HALL OF FAME CAR WASH AT WALLBROOK (LOT 8)

Town of Rolesville Project Numbers: SDP 25-01 / CID 24-03

V1

#	DATE	DESCRIPTION
1	2-JAN-25	INITIAL SUBMITTAL FOR REVIEW

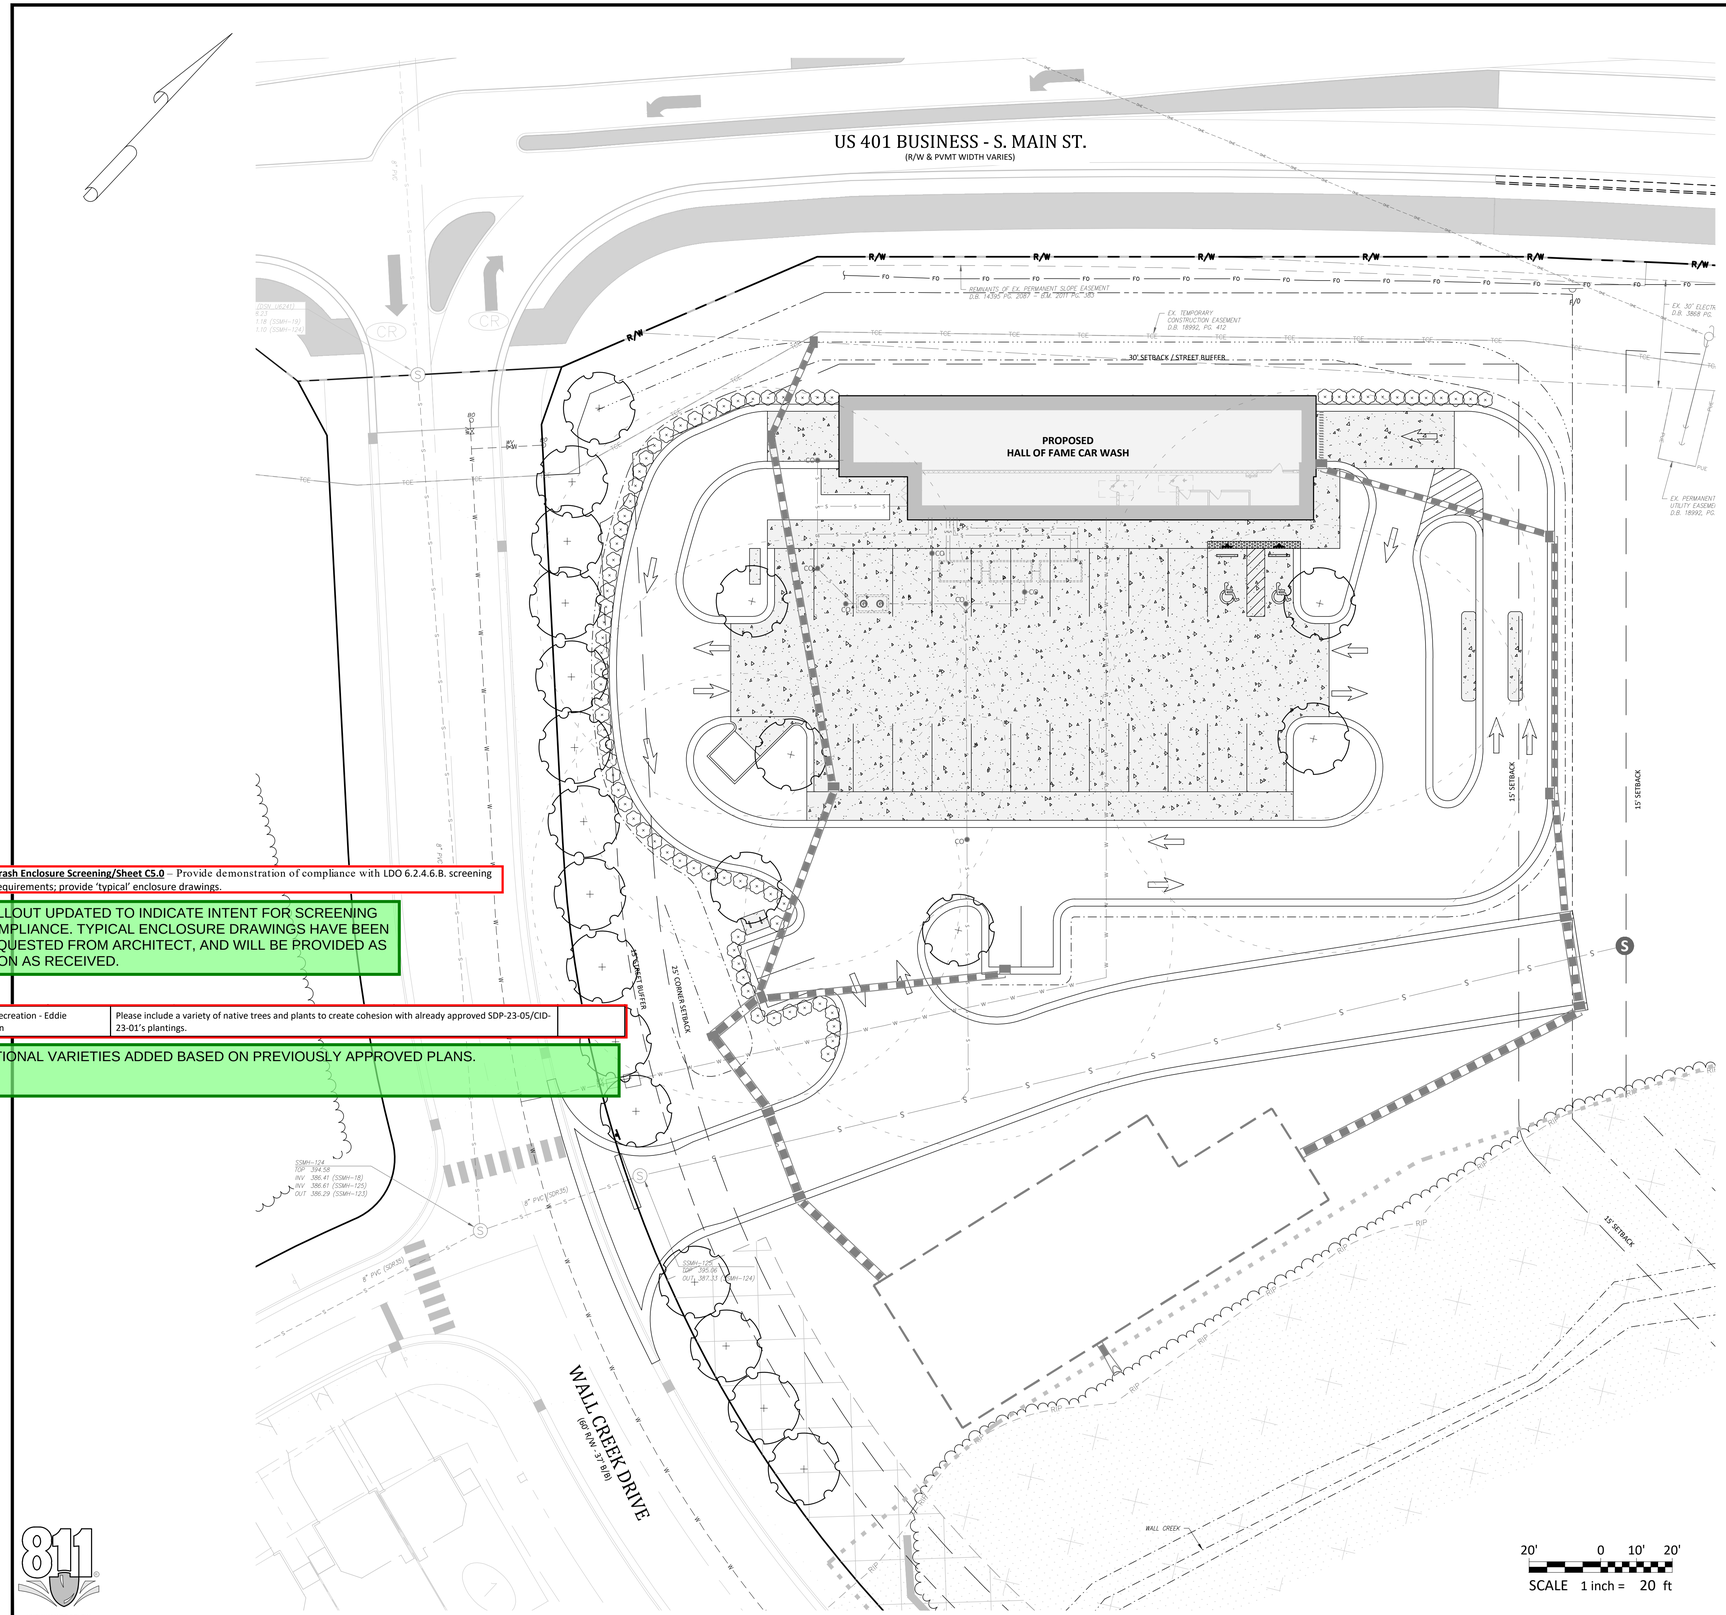
6. **Trash Enclosure Screening/Sheet C5.0** – Provide demonstration of compliance with LDO 6.2.4.6.B. screening requirements; provide 'typical' enclosure drawings.

CALLOUT UPDATED TO INDICATE INTENT FOR SCREENING COMPLIANCE. TYPICAL ENCLOSURE DRAWINGS HAVE BEEN REQUESTED FROM ARCHITECT, AND WILL BE PROVIDED AS SOON AS RECEIVED.

ADDITIONAL VARIETIES ADDED BASED ON PREVIOUSLY APPROVED PLANS.
